EXISTING FACILITIES

FIRE STATION #2 – N MAIN St, Milan, TN

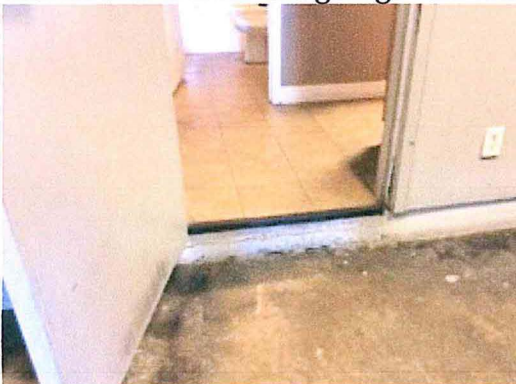
The side entrance into the living quarters has hardware that requires gripping or twisting. The door also closes faster than 5 seconds.

The entrance from the garage into the living area has a step.

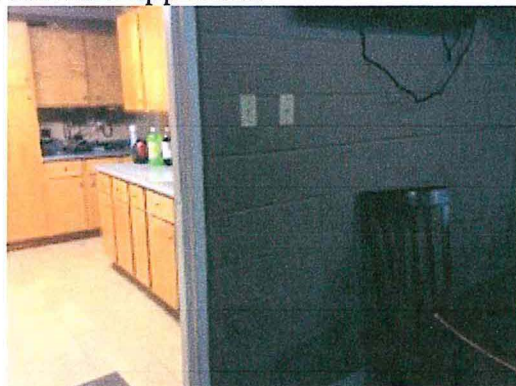
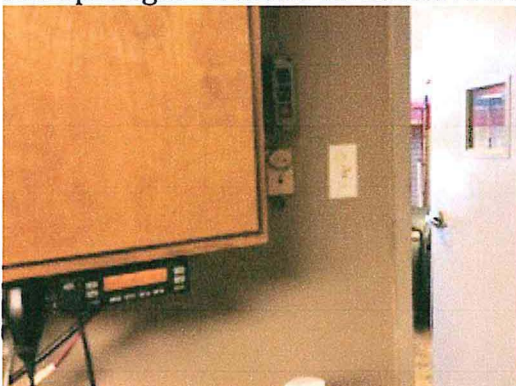
While the routes are navigable they can be tight.
